SUBJECT: Forwards response to NRC 800207 questions re fire protection. Addl responses will be submitted no later than 800601. Mods necessary to provide adequate fire protection will be completed by 801031.

H. B. ROBINSON STEAM ELECTRIC PLANT UNIT NO. 2
DOCKET NO. 50-261
LICENSE NO. DPR-23

FIRE PROTECTION PROGRAM - DEDICATED SHUTDOWN SYSTEM

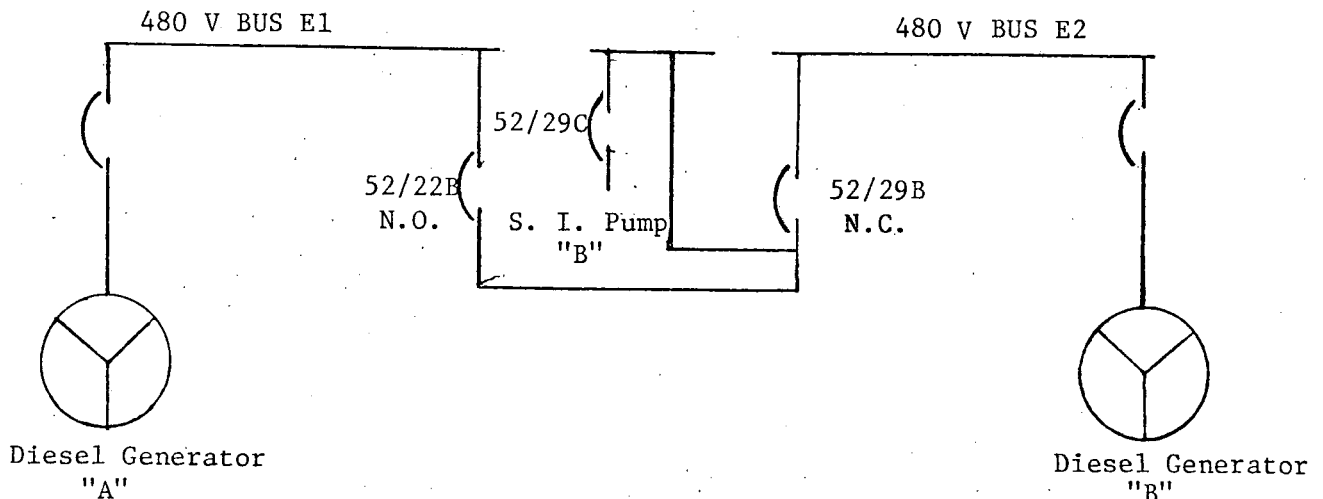
- S5. Clarify the discrepancy between the first and fourth paragraphs of FSAR page 8.2-13 with regard to the transfer of loads from one diesel generator to the other.

The following is a one-line diagram of the E1-E2 cross tie as mentioned on page 8.2-13 of the FSAR.

Breakers 52/22B and 52/29B have automatic interlocks which prevent both breakers from being closed at the same time. The first paragraph on page 8.2-13 of the FSAR refers to the case where one of the emergency diesel generators does not start and come on line as required. The automatic interlock could be manually defeated so that both tie breakers could be manually closed at the same time, thus feeding both E1 and E2 from one diesel generator.

The fourth paragraph on page 8.2-13 of the FSAR refers to assuring a power supply to Safety Injection (S.I.) Pump "B". Normally S.I. Pump "B" is fed from 480 V. Bus E2. If there was a loss of off-site power concurrent with a safety injection actuation and diesel generator "B" did not start up, breaker 52/29B would automatically close thus ensuring a power supply to S. I. Pump "B" from 480 V. Bus E1 and 480 V. Bus E2 are not tied together in this case.
